Hunter Valley Operations South - Modification 5

Response to submissions

Prepared for HV Operations Pty Ltd | June 2017

Figure 4.4

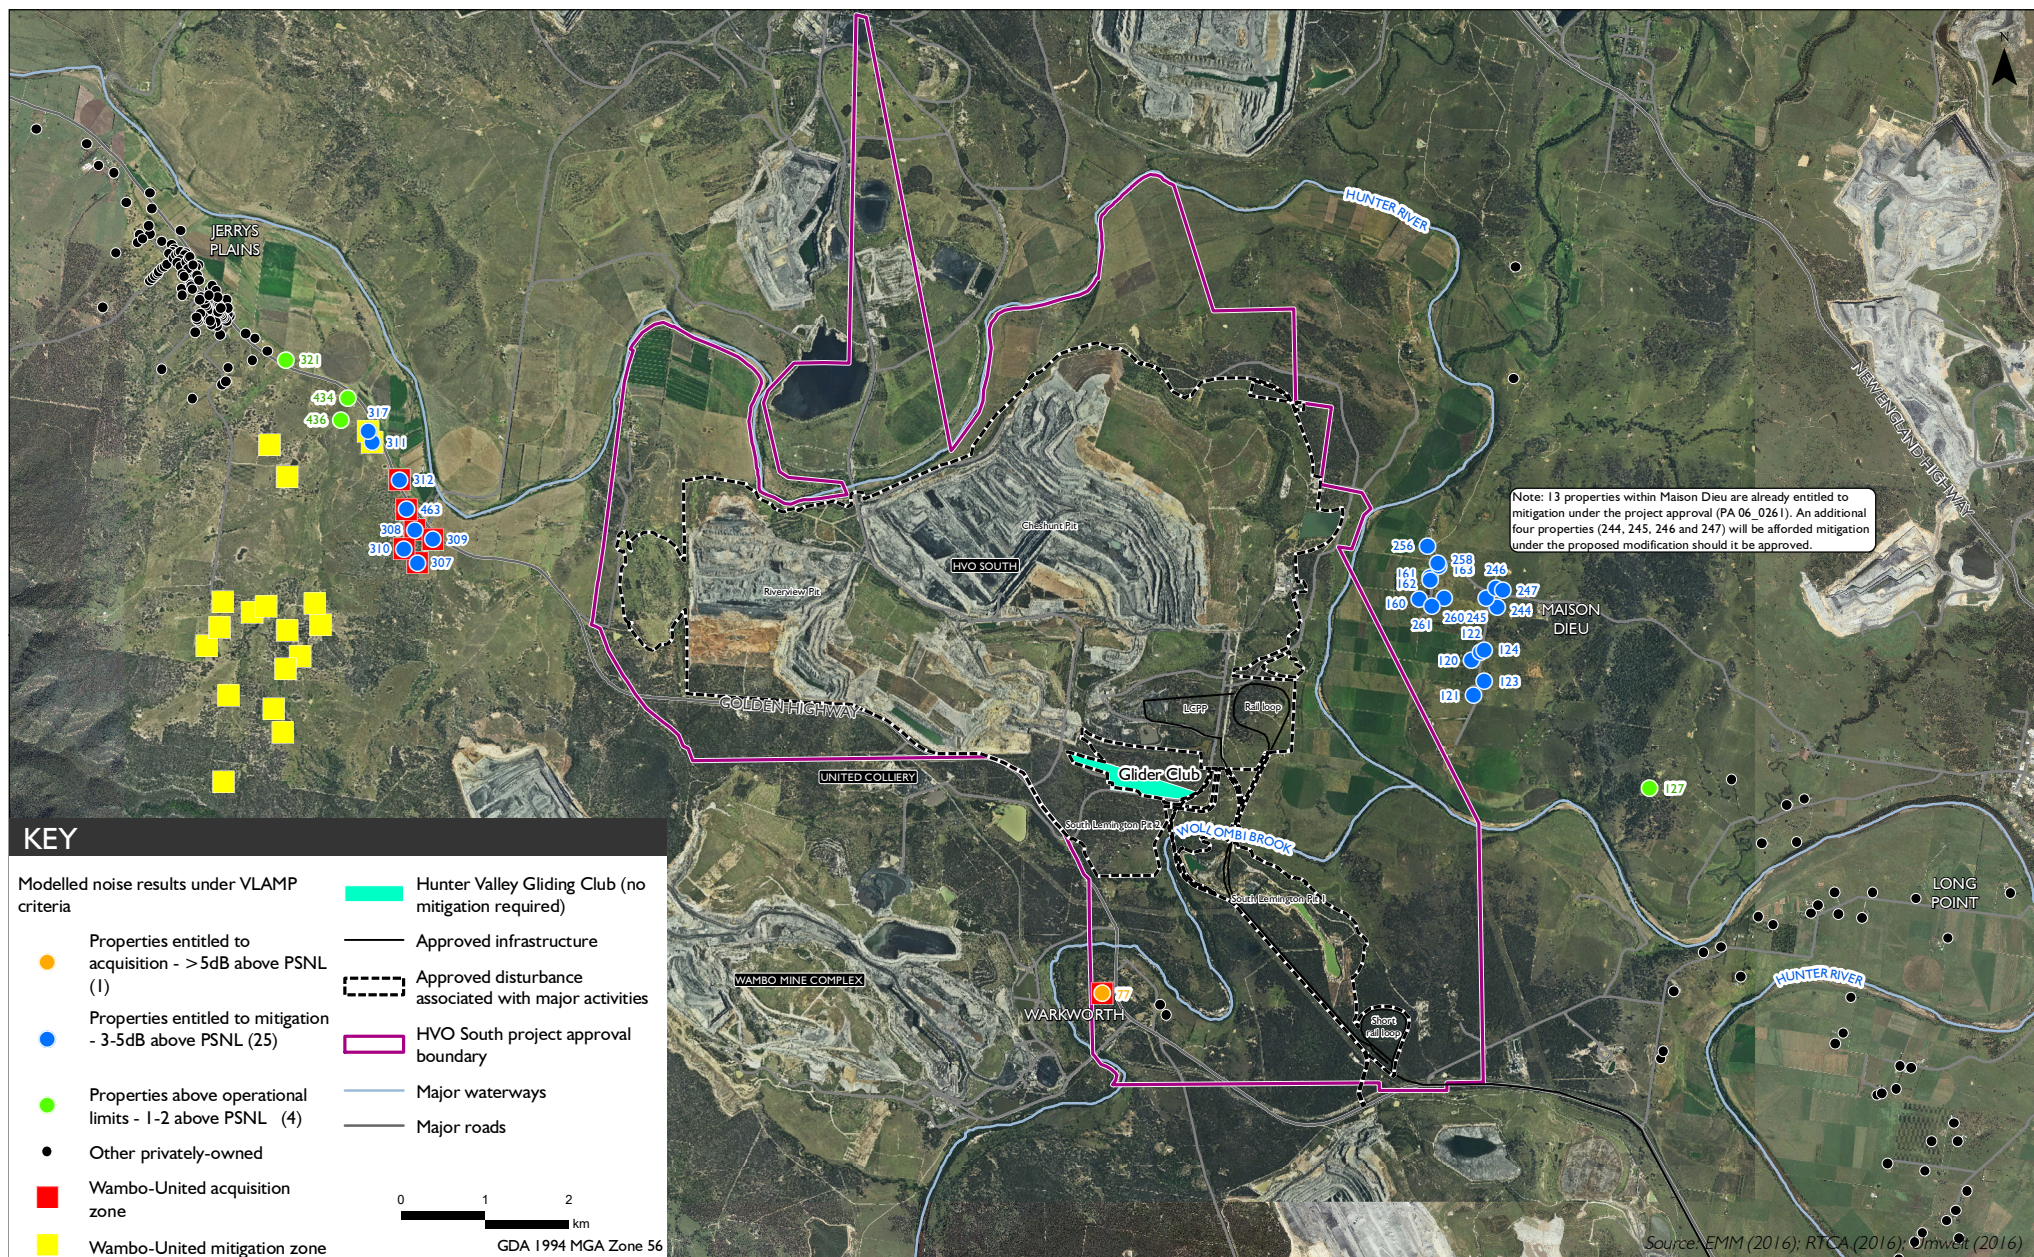
In response to this request Coal & Allied has updated the noise modelling results in Figure 7.1 of the EA to show the location of the Hunter Valley Gliding Club. The updated figure is included in Figure 4.4 of this RTS and has been provided to the Hunter Valley Gliding Club for their information.
